Denial

Subject: Mine Ventilation Plan, Section 75.370, 30 CFR 75, Upper
Big Branch Mine-South, I.D. No. 46-08436, Performance
Coal Company, Montcoal, Raleigh County, West Virginia

Re: Performance Coal Company
Upper Big Branch Mine
MSHA ID : 46-08436
State ID: U-3042-92
Ventilation Revision

Northern District Longwall Bleeder System

TYPICAL LONGWALL FACE VENTILATION

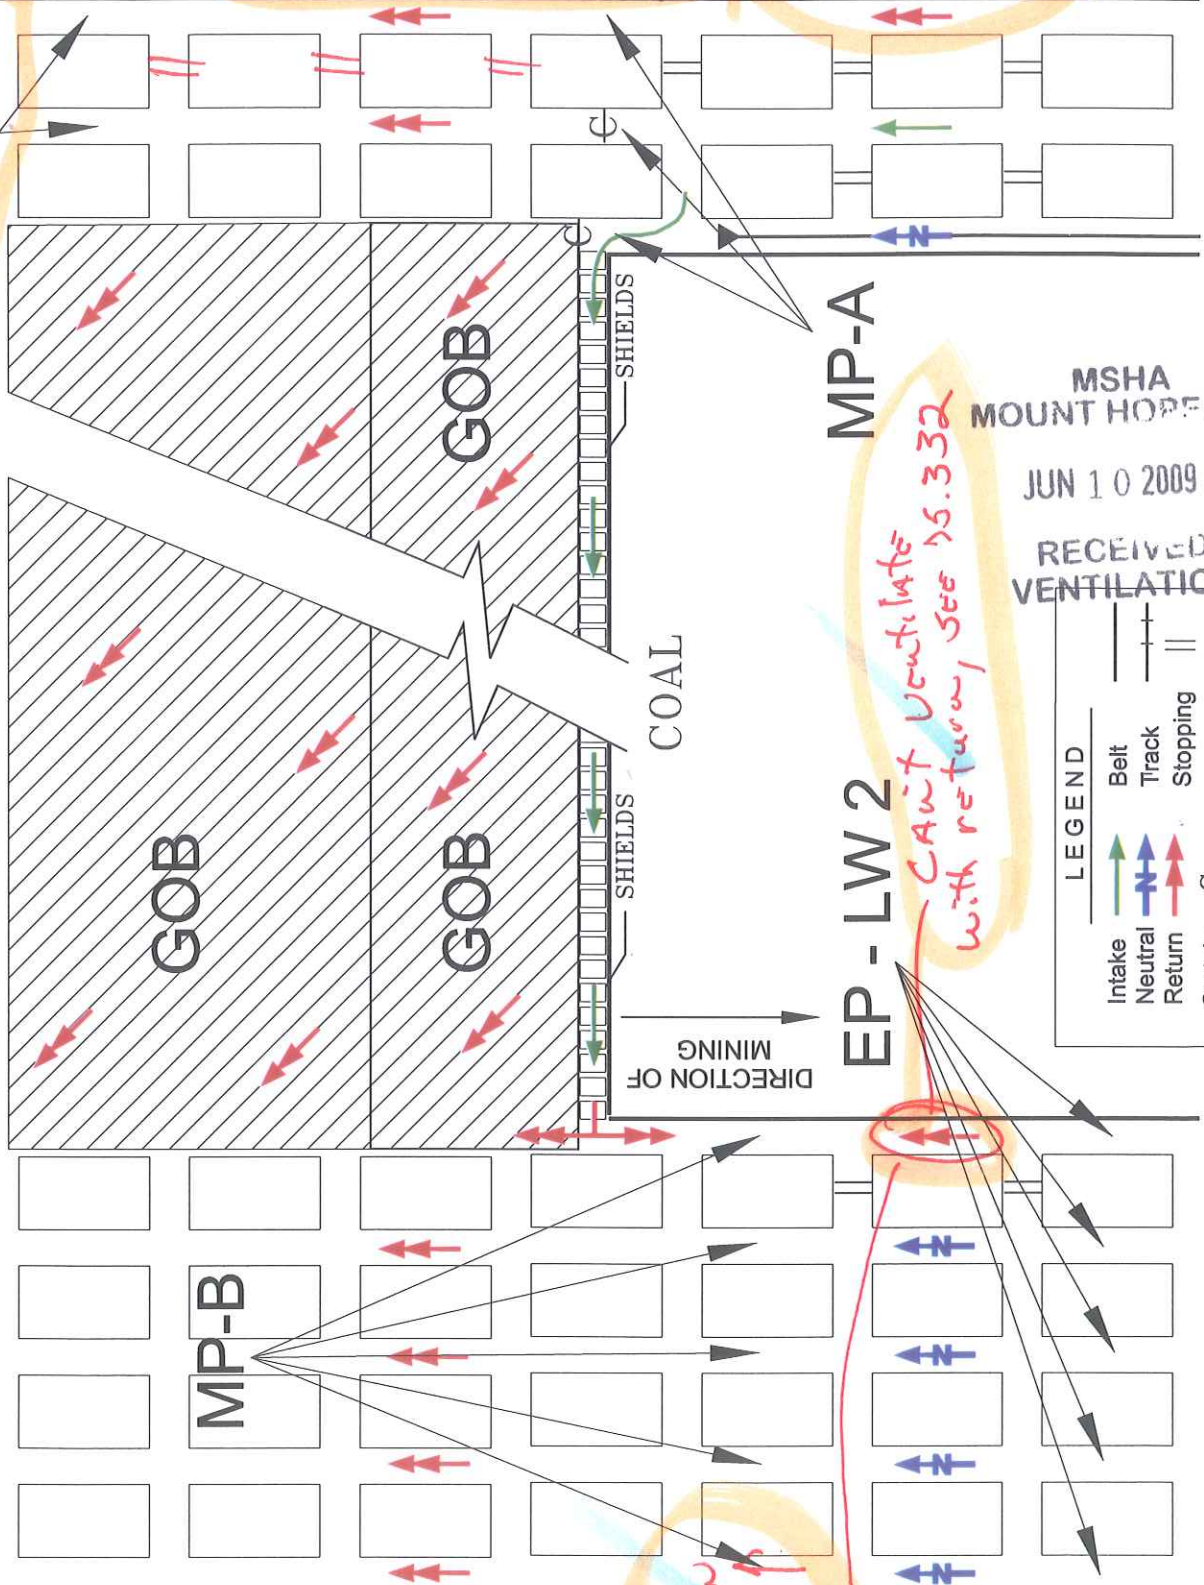
Add another face sketch
showing 4 Gate entries

STATE Stoppings to be left intact to separate
Active section Return from longwall Gob also provides
separation from #1 wall Gob from #2 wall Gob.

Also need face sketch with 4 Gate Entries for North Bleeder system

Show LEAVENS STOPPING IN PLACE for Return from Section 029-0 030-0 STOPMENTS TO FAN

To comply with 75.334 whoa mining #2 Panel

CAUTION Ventilate with return, see 75.332

Recommendations Isolating return #1 Fan To
